Intermodal Logistics Centre: Enfield Modification Application No 8

**Subdivision - Changes and Amendments**

ILC – E – PT3A – Modification Application No 8 2 September 2013

Figure 2: Proposed subdivision as a result of Modification No 8

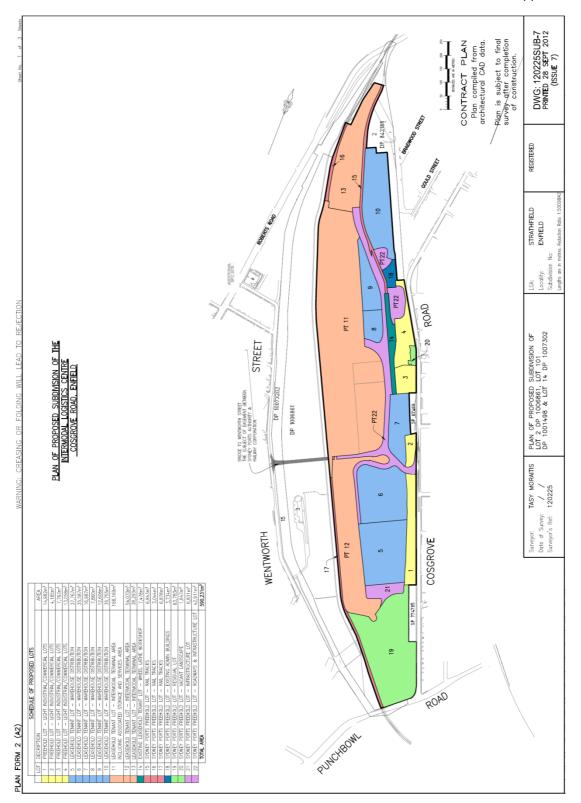
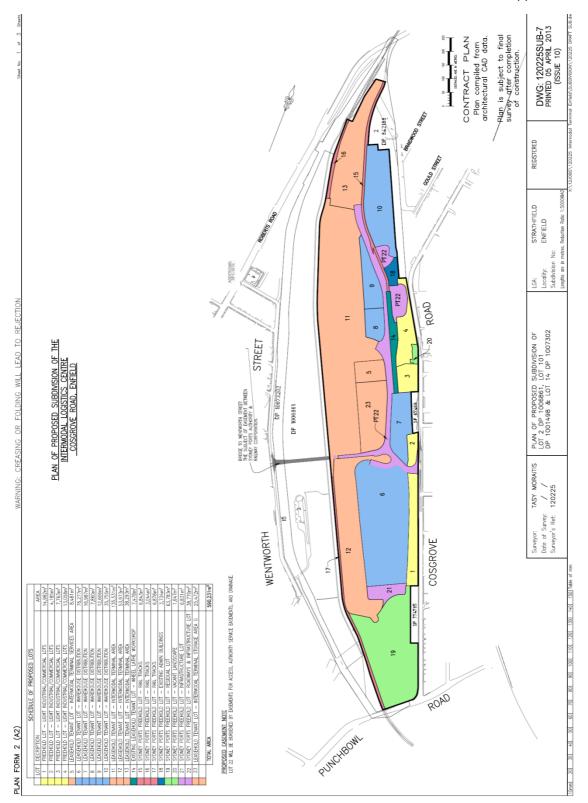
Warehouse Areas A and B are proposed to be merged from two lots (Lots 5 and 6) into one lot (Lot 6 - 76,277 m²) to enable consolidation of services.

- The area under the bridge within the ILC intermodal terminal has been reallocated from Lot 12 to Lot 11, as it will be paved with the rest of the intermodal terminal.
- A further subdivision of a portion of Lot 11 (the Intermodal Terminal Area) to provide two additional allotments is necessary to optimise the operation of the ILC in accordance with its approved land use. The two additional allotments to be created comprise:
  - o Lot 5: Intermodal Services Area (8,481 m<sup>2</sup>); and
  - o Lot 23: Intermodal Storage Area G (25,472 m<sup>2</sup>).

The combined changes result in Lot 11 being reduced in area from 168,169  $\text{m}^2$  to 135,531  $\text{m}^2$  and Lot 12 reduces in area from 54,070  $\text{m}^2$  to 53,973  $\text{m}^2$ .

- merging Lots 5 and 6 into one allotment (Lot 6);
- reallocating the area under the road bridge within the intermodal terminal from Lot 12 to Lot 11; and
- subdividing a portion of Lot 11 to provide two additional allotments (Lot 5 and Lot 23).

- 1. Replacing Appendix 1 (Plan of Subdivision DWG:120225SUB-7 Issue 7) with the Subdivision Plan shown in Figure 2 (DWG:120225SUB-7 Issue 10); and
- 2. Amending CoA 1.1 to include references as appropriate to this Modification Application No 8 and the revised subdivision plan drawing number and date.
